Access Compliance Report

Public Rights-of-Way

(Curb Ramps)

Intersection ID: 46304	Main Street: AUGUSTINE_WY	Cross Street: MERMANS_RD	Location: NE
ADA ID: 6EBFFDF95778	Ramp Type: PerpDiag	Initial Pass/Fail: Fail	Overall Compliance: No
Severity Score: 21.25			
Codes/Mitigation Info/Possible Solution		Field Measurements/Component Compliance

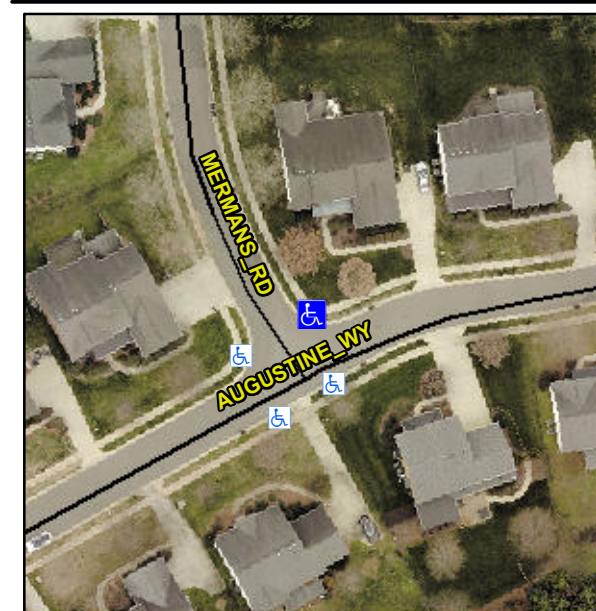
Not Found, R304.5.1, R304.5.3

Compliance	Description	Data	Compliance	Description	Data
N/A	Ramp Length (in)	46.5	Yes	Ramp Slope (%)	7.5
No	Ramp Width (in)	39.0	No	Ramp XSlope (%)	6.6
N/A	Flare Type LT	N/A	N/A	Flare Type RT	N/A
N/A	Flare Slope LT (%)	N/A	N/A	Flare Slope RT (%)	N/A
N/A	Flare Traversable LT?	N/A	N/A	Flare Traversable RT?	N/A
N/A	Landing Length (in)	N/A	N/A	DWS Provided?	N/A
N/A	Landing Width (in)	N/A	N/A	DWS Contrast?	N/A
N/A	Landing Slope (%)	N/A	N/A	DWS Length (in)	N/A
N/A	Landing X Slope (%)	N/A	N/A	DWS Full Width?	N/A
N/A	Landing Curb? (Y/N)	N/A	N/A	DWS Offset (in)	N/A
N/A	Shared Landing?	N/A			
N/A	Gutter Ponding?	N/A	N/A	Gutter Slope (%)	N/A
N/A	Gutter Lip Ht (in)	N/A	N/A	Gutter X Slope (%)	N/A
N/A	Painted X Walk1?	No	N/A	Painted X Walk2?	No
	X Walk 1 Direction	To W		X Walk 2 Direction	To S
N/A	X Walk 1 Width (in)	N/A	N/A	X Walk 2 Width (in)	N/A
	X Walk 1 Slope (%)	0.4		X Walk 2 Slope (%)	5.9
	X Walk 1 X Slope (%)	5.9		X Walk 2 X Slope (%)	3.6

Remove & Replace Curb Ramp With Two New Directional Ramps or Equivalent.
